February 23, 2011

Exponent is pleased to provide the comments presented below on the January 11, 2011, document, “Public Health Goal for Perchlorate in Drinking Water”, which was prepared by the Office of Environmental Health Hazard Assessment (OEHHA) within the California Environmental Protection Agency (CalEPA). We are presenting these comments on behalf of Whittaker Corporation.

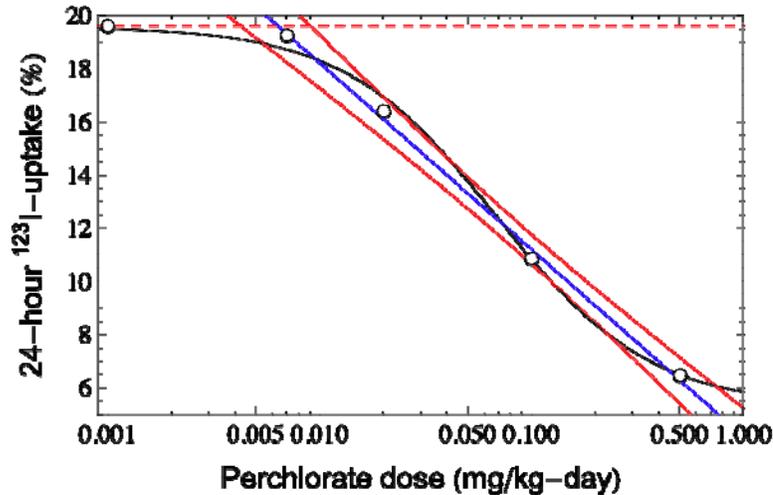
The data to which the BMD model was fit, summarized in Table 39 on page 103 of the CalEPA OEHHA (2011) PHG report, are deviations in the 24-hour percent of radio-labeled iodine taken up by thyroid in the human subjects studied by Greer et al. (2002). The Hill-model parameter values listed in the report do not appear to correspond to the fit actually depicted, and incorporate an intercept term arbitrarily forced to equal zero. Alternative parameter values with a forced zero intercept give a reasonably similar plot in relation to the data fit by OEHHA. The key problem with the data fit OEHHA obtained is that the baseline data were omitted entirely from the analysis, together with their combined ~22.6% coefficient of variation, and any discussion of either the fact that baseline uptakes varied from ~10 to 35%, or the health

implications of this range of natural variation in baseline uptake in symptomatically normal human subjects. Rather, only non-baseline data were included in the fit, after normalizing as percentages of corresponding dose-group-specific sets of uptake data. The dose-specific 24-hour baseline data from the Greer et al. study are statistically homogeneous (by 1-way analysis of variance, $p = 0.62$), as are their variances (by Bartlett's test, $p = 0.24$). Therefore, ignoring the absolute values of the baseline data, and their combined variance, in the fitting procedure used by OEHHA resulted in a misleading fit to the data that mischaracterized the variance associated with its fitted parameters. The possible perchlorate exposures of subjects at or just prior to each baseline measure was not discussed by Greer et al. (2002). However, that study took place in the Portland, OR, area, which is not an area known to have elevated levels of perchlorate in drinking water (Jenkins and Sudakin, 2006). Figure 1 shows the un-normalized baseline and dose-specific 24-hour iodine-uptake percentage data from the Greer et al. (2002) study, with perchlorate exposures for all baseline measures are set to a reasonably low value of 1 microgram per kg body weight per day, with dose values plotted on a logarithmic scale. The approximate OEHHA Hill-model fit (black curve), is compared to a better fitting 2-parameter log-linear model fit (blue curve) to the four non-baseline data points. The fit, and associated 2-tail 90% confidence intervals (red curves), were obtained using the *Mathematica* 8.0 NonlinearModelFit function, with weights set to the product of sample size and inverse sample variances (Wolfram 2011). The lower 2-tail 90% (i.e., lower 1-tail 95%) confidence limit log-linear fit implies that doses below 0.004 mg/kg-day would appear unlikely to affect iodide uptake at all based on measures made among subjects studied by Greer et al. (2002). The toxicological significance of doses between this apparent threshold and 0.02 mg/kg-day is not clear in view of the substantial magnitude of variation in baseline iodine-uptake rates (down to ~10%) exhibited among the symptomatically normal subjects in this study.
